Re: Design Exceptions #DE 5-05 and #DE 6-05 - Redlands Mesa Phase 4 – Street Light Spacing and Cul-de-sac Length

DESIGN EXCEPTION #DE 6-05

RE: Cul-de-sac Length – Redlands Mesa (Chapter 5.1.3)

DATE:	1/20/05
SCALE:	Horiz: 1" = 100' Vert: N/A
PROJECT NO.:	0356-027
SHEET NO.:	2 OF 7
THOMPSON-LANGFORD CORP. ENGINEERS AND LAND SURVEYORS 529 25 1/2 RD., SUITE 2E10 GRAND JUNCTION, COLORADO PH. (970) 243-8067 FAX (970) 241-2845 tlc@tlwest.com	REDLANDS MESA PHASE 4 PRELIMINARY SITE PLAN

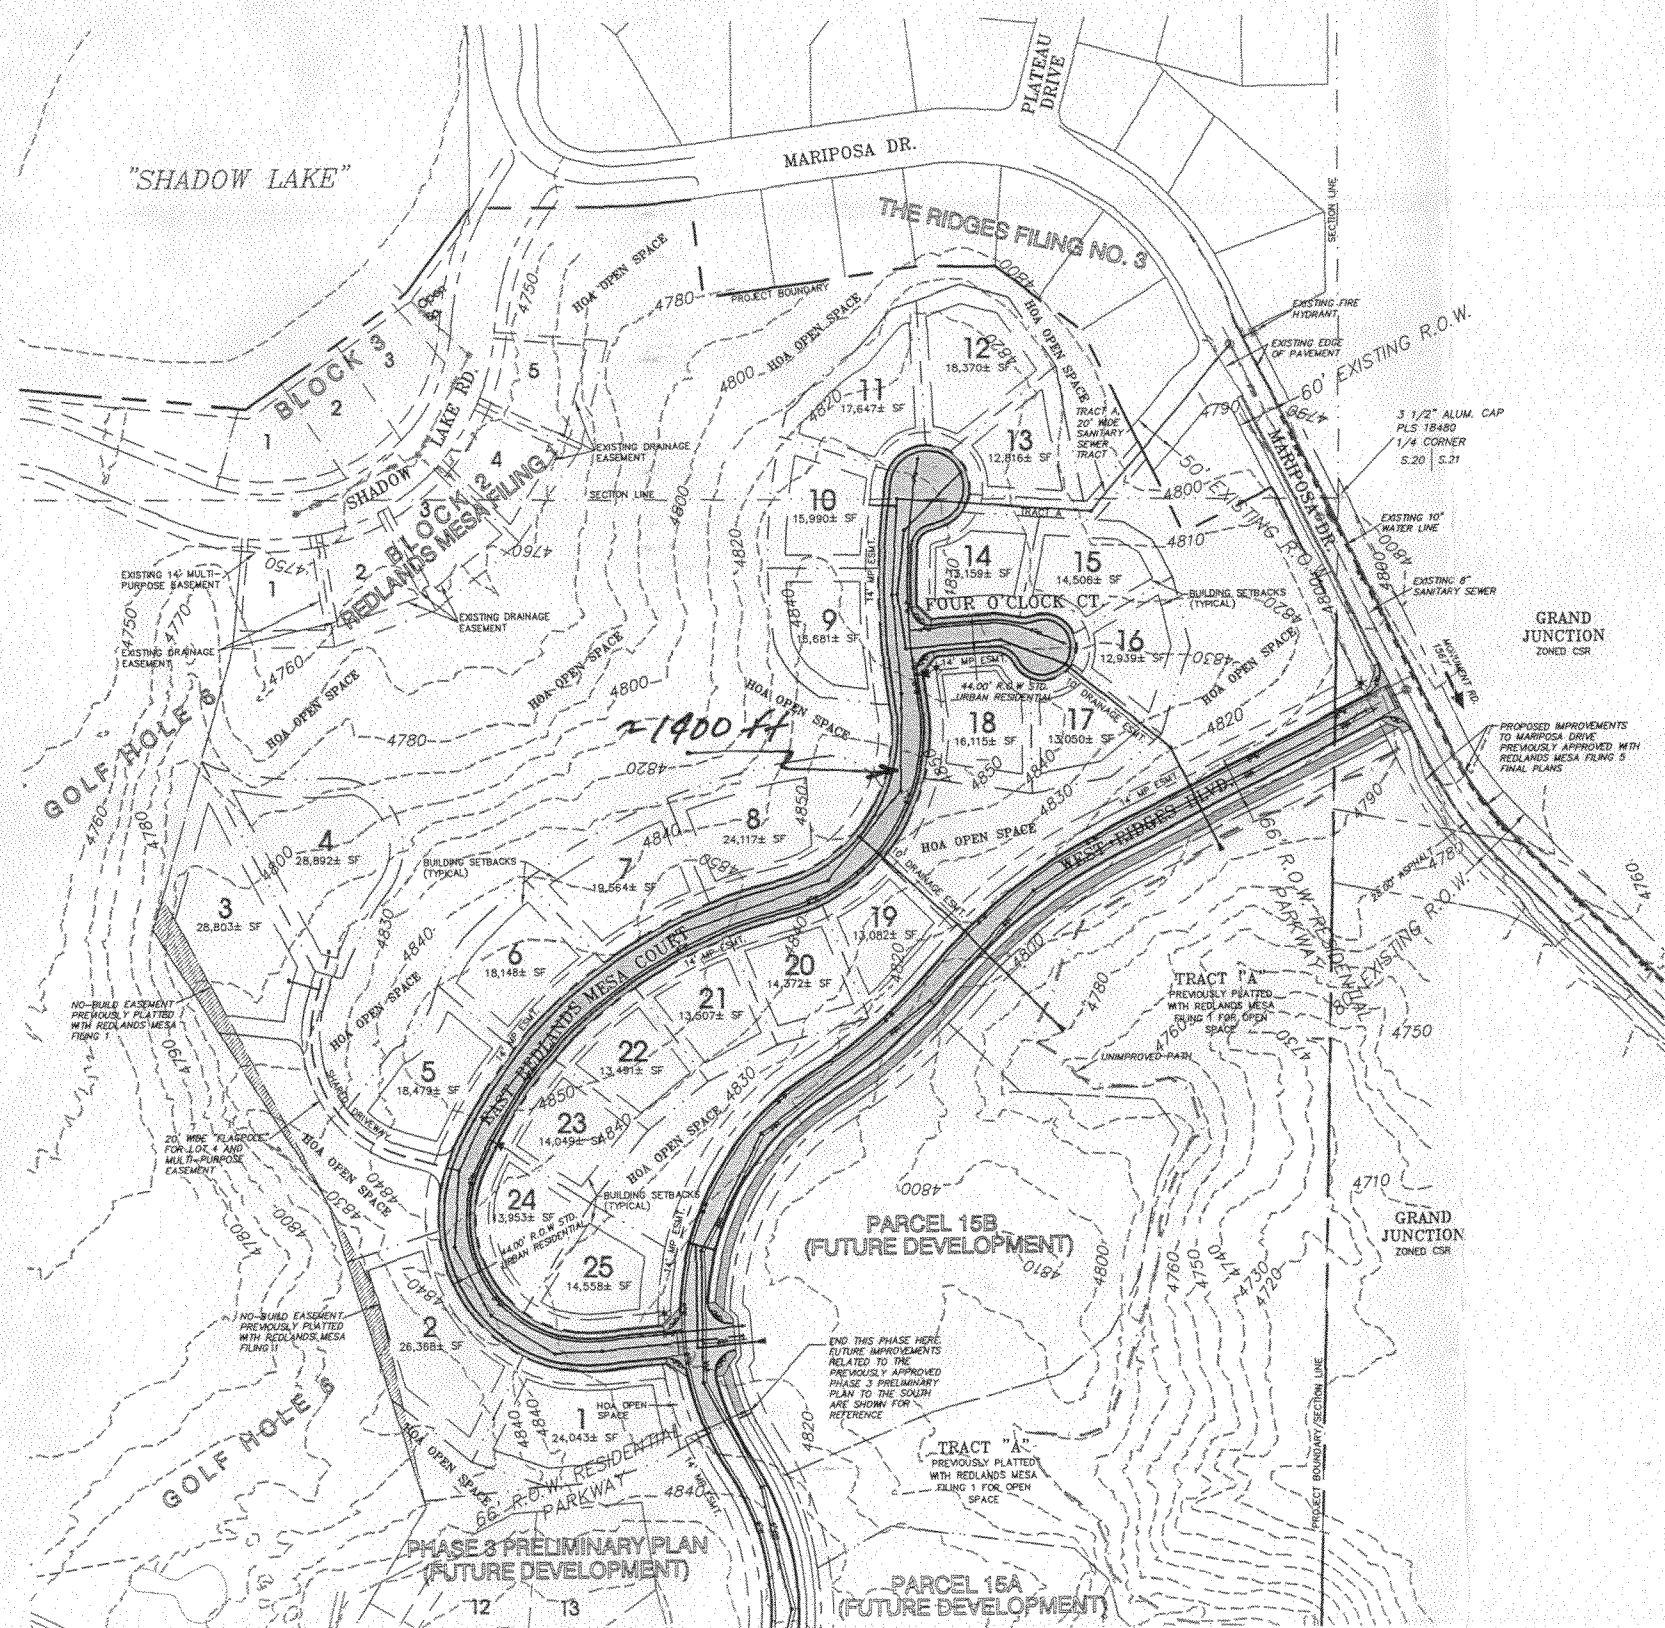
Street Lighting — consistent w/ other phase

Proposed Exception: Street light spacing and frequency of occurrence.

Proposed design: Street lights are to be installed at all intersections consistent with previously approved Redlands Mesa Filings.

Proposed Exception: Cul-de-sac lengths in excess of 750 lf have resulted from the attempt to most efficiently utilize the developable area with respect to topography. This occurs on East Redlands Mesa Drive (approximately 1400 ft).

Impacts of change: The extended cul-de-sac length, for a limited number of lots (25), is a much more desirable configuration considering the safety and construction issues associated with the alternative.

Please find attached the committee's decision for the above referenced requests. These design exceptions have been approved as requested. You may use this decision to proceed through the development review process for this exception.

Staff recognizes the need to vary from the Cul-de-sac standard and recommends approval of this Exception as requested.
